# Access Compliance Report

## Public Rights-of-Way

### (Curb Ramps)

Intersection ID: 53401	Main Street: VAWTER_DR	Cross Street: AGNEW_DR	Location: SW
ADA ID: F7A05230472E	Ramp Type: Perp	Initial Pass/Fail: Fail	Overall Compliance: No
		Severity Score: 10

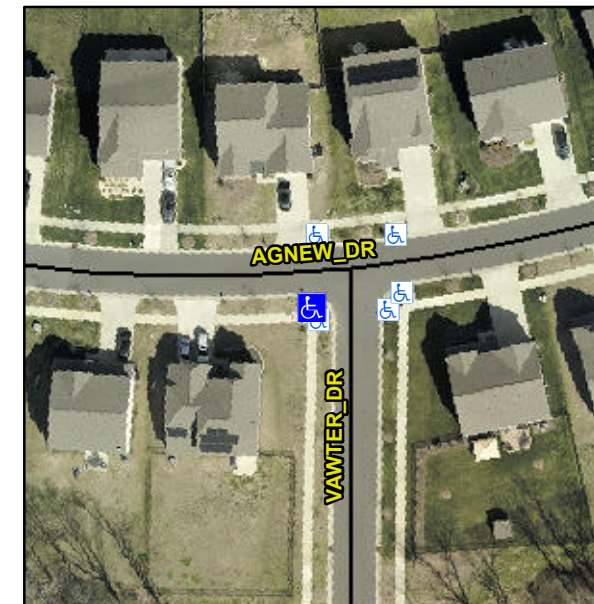
**R304.5.1**

Compliance	Description	Data	Compliance	Description	Data
N/A	Ramp Length (in)	99.0	Yes	Ramp Slope (%)	6.7
No	Ramp Width (in)	47.0	Yes	Ramp XSlope (%)	2.5
N/A	Flare Type LT	N/A	N/A	Flare Type RT	N/A
N/A	Flare Slope LT (%)	N/A	N/A	Flare Slope RT (%)	N/A
N/A	Flare Traversable LT?	N/A	N/A	Flare Traversable RT?	N/A
N/A	Landing Length (in)	N/A	N/A	DWS Provided?	N/A
N/A	Landing Width (in)	N/A	N/A	DWS Contrast?	N/A
N/A	Landing Slope (%)	N/A	N/A	DWS Length (in)	N/A
N/A	Landing X Slope (%)	N/A	N/A	DWS Full Width?	N/A
N/A	Landing Curb? (Y/N)	N/A	N/A	DWS Offset (in)	N/A
N/A	Shared Landing?	N/A			
N/A	Gutter Ponding?	N/A	N/A	Gutter Slope (%)	N/A
N/A	Gutter Lip Ht (in)	N/A	N/A	Gutter X Slope (%)	N/A
N/A	Painted X Walk1?	No	N/A	Painted X Walk2?	N/A
	X Walk 1 Direction	To N		X Walk 2 Direction	N/A
N/A	X Walk 1 Width (in)	N/A	N/A	X Walk 2 Width (in)	N/A
	X Walk 1 Slope (%)	3.3		X Walk 2 Slope (%)	N/A
	X Walk 1 X Slope (%)	2.8		X Walk 2 X Slope (%)	N/A

**Remove & Replace Entire Ramp.**
